North Coast Regional Water Quality Control Board

Subject: Notice of Violation, Transmittal of Inspection Report for September 7, 2023, Inspection of Humboldt County Assessor's Parcel Number 107-054-036-000, and Requirement to Respond within 30 days

North Coast Regional Water Quality Control Board
Cannabis Water Quality Inspection Report
 APN(s): 107-054-036-000

Figure 1: Site Map with dashed parcel boundaries and points (P), line (L), and area (A) of interest. P7 was determined to be off parcel and is not included in this map or report.

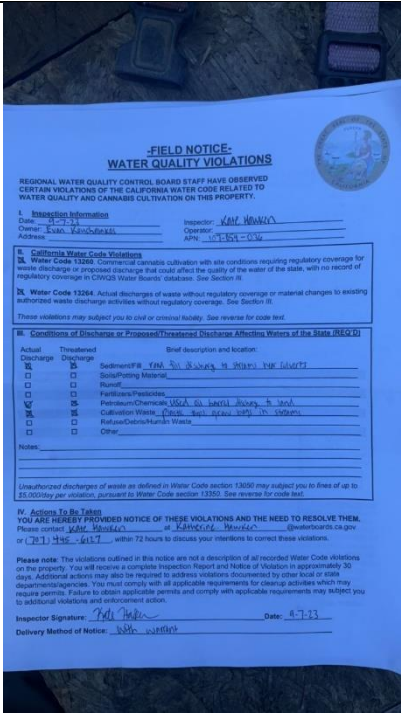
P1: I observed two hoop houses with plastic flooring, and cannabis plants in pots. I observed a pile of potting soil in front of the hoop houses. I left a field notice on the property with the warrant.

P2: I observed a barrel full of suspected used motor oil. The area smelled of petroleum and I observed a discharge to land at the base of the barrel where the ground was blackened.

P3: I observed a 16-inch diameter plastic culvert stream crossing with ponding at its inlet. I observed a clogged metal culvert left in the road prism, and evidence of the stream overtopping the road. I observed a road ditch discharging to the stream at the culvert inlet.

P4: I observed a spring with an approximately 50-foot wet area below it. I observed electrical conduit in the spring channel.

P5: I observed inactive water storage bladders, and water storage tanks on a flat.

P6: I observed a groundwater well in an upland area. The well did not appear to be connected to the cultivation area.

P8: I observed a plastic culvert stream crossing with ponding at its inlet. I observed a disconnected submersible pump in the ponded area. I observed a road ditch discharging to the stream at the culvert inlet. I observed trash at the culvert outlet, and the road prism eroding into the stream.

L1: I observed a watercourse channel with portions of cobble substrate, and dirt substrate. I observed cultivation related waste in the stream. I observed the stream discharges to a pond/ wetland feature.

A1: I observed a pond/ wetland feature with hydrophytic plants including rushes, willows, penny royal, and grasses. I observed cultivation related waste in the pond/ wetland. I observed a metal culvert connecting the wetland/ pond at high flows to an adjacent watercourse running along the northwest parcel boundary. I observed the wetland/ pond feature was approximately 20 feet from the cultivation area P1 at the closest edge.

1. If you and/or your tenant(s) plan to continue commercial cannabis cultivation, enroll for coverage under the State Water Board's Order WQ 2019-0023-DWQ, General Waste Discharge Requirements and Waiver of Waste Discharge Requirements for Discharges of Waste Associated with Cannabis Cultivation Activities.
2. Relocate all cannabis cultivation activities, supplies, and trash outside of the riparian setbacks (50 feet from Class III, 100 feet from Class II, 150 feet from Class I).
3. Regularly contain and dispose of all waste/ trash, including used motor oil, at a licensed transfer site. Remove cultivation related waste from surface waters.

4. Retain a qualified professional to assess the culvert stream crossings for capacity to convey a 100-year flow event and associated debris, disconnect road ditches from watercourses, and recontour roads to prevent discharge to receiving waters.
5. Apply for a 401 water quality certification prior to work instream to replace culverts.
6. Work with the State Water Board Division of Water Rights and the California Department of Fish and Wildlife to obtain necessary permits to divert and store water.
7. Do not use water storage bladders unless the bladder is safely contained within a secondary containment system with sufficient capacity to capture 110 percent of a bladder's maximum possible contents in the event of bladder failure.
